Project	IEEE 802.16 Broadband Wireless Access Working Group < http://ieee802.org/16 >
Title	Ranging Primitive Example
Date Submitted	2006-09-26
Source(s)	Peretz Feder - Lucent Technologies [mailto: pfeder@lucent.com]
Re:	
Abstract	This contribution is an addendum to Appendix F
Purpose	Adoption
Notice	This document has been prepared to assist IEEE 802.16. It is offered as a basis for discussion and is not binding on the contributing individual(s) or organization(s). The material in this document is subject to change in form and content after further study. The contributor(s) reserve(s) the right to add, amend or withdraw material contained herein.
Release	The contributor grants a free, irrevocable license to the IEEE to incorporate material contained in this contribution, and any modifications thereof, in the creation of an IEEE Standards publication; to copyright in the IEEE's name any IEEE Standards publication even though it may include portions of this contribution; and at the IEEE's sole discretion to permit others to reproduce in whole or in part the resulting IEEE Standards publication. The contributor also acknowledges and accepts that this contribution may be made public by

Figure F9 – The use of Ranging Primitives

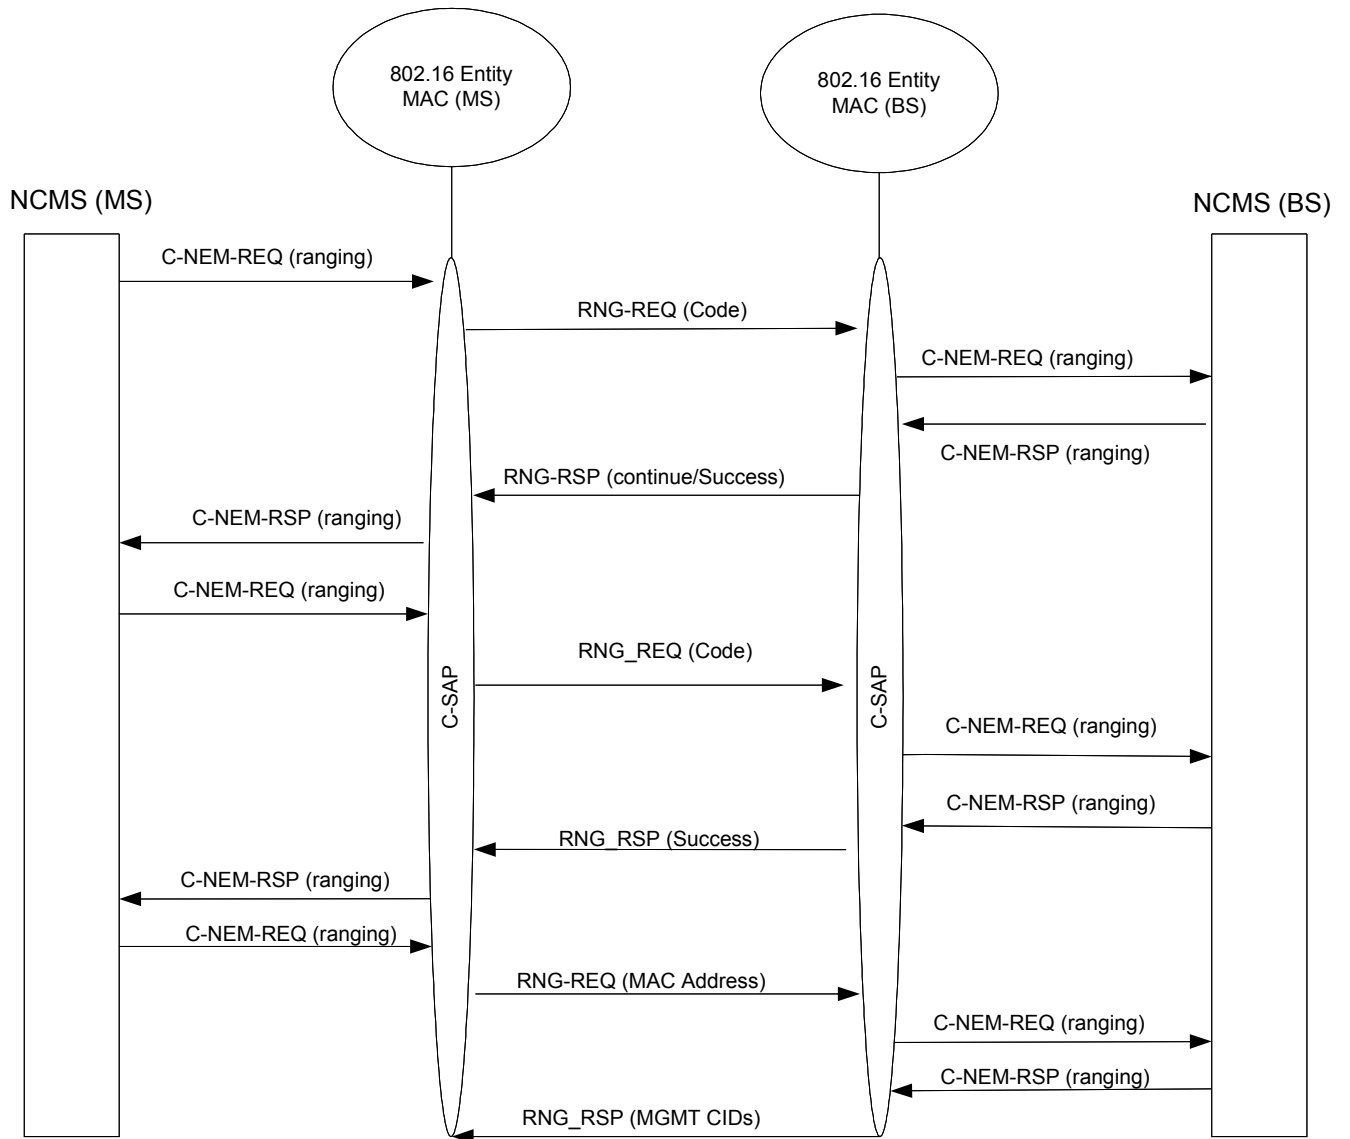
Add Section F.4

Add the following Figure to the Annex F
